REMARKS/ARGUMENTS

AMENDMENT TO THE DRAWINGS

The attached Replacement Sheet of drawings includes changes to Fig. 9 wherein:

FIG 9

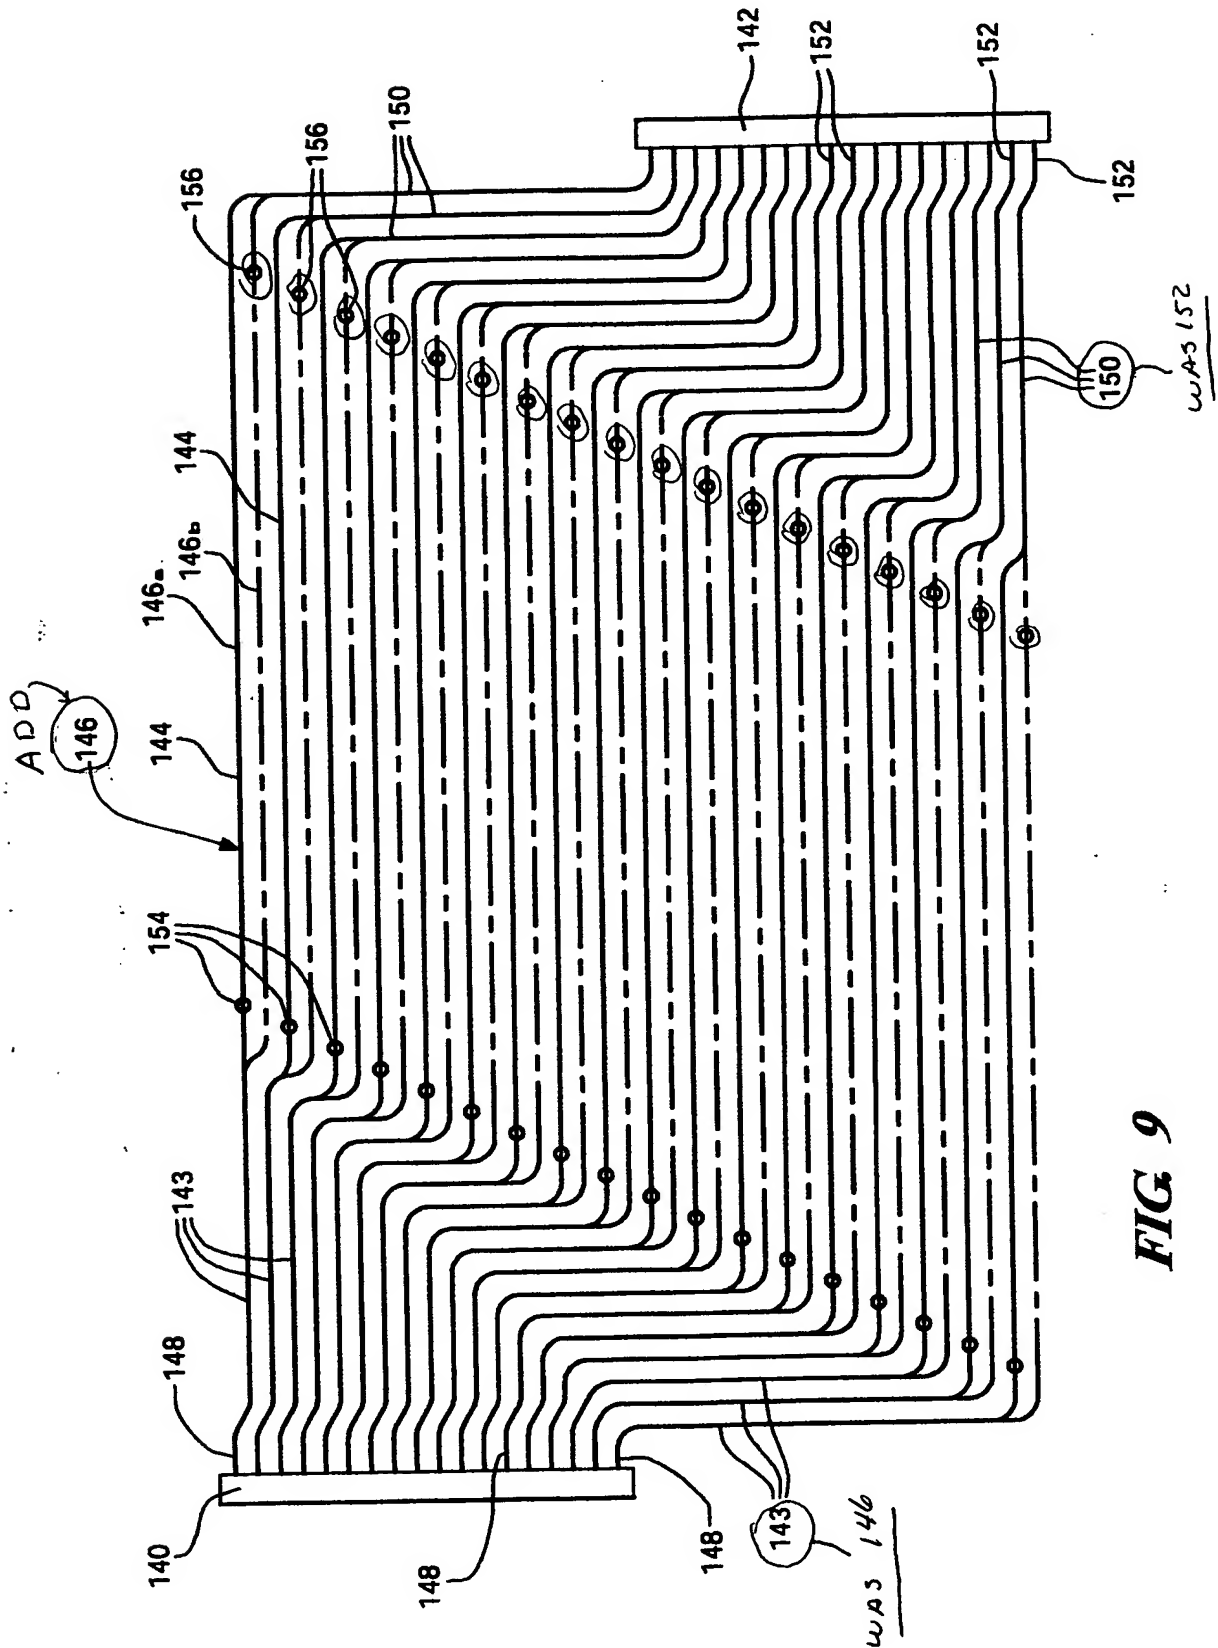
(1) old number 146 has been changed to 143; (2) new number 146 has been added to designate the medial legs of the flow-channels, (3) old number 152 that designated the exit legs has been changed to 150, and (4) flow-restrictors 156 are relocated from flow-channels 146a to flow-channels 146b. An annotated copy of the drawing, showing the changes in red, is also attached.
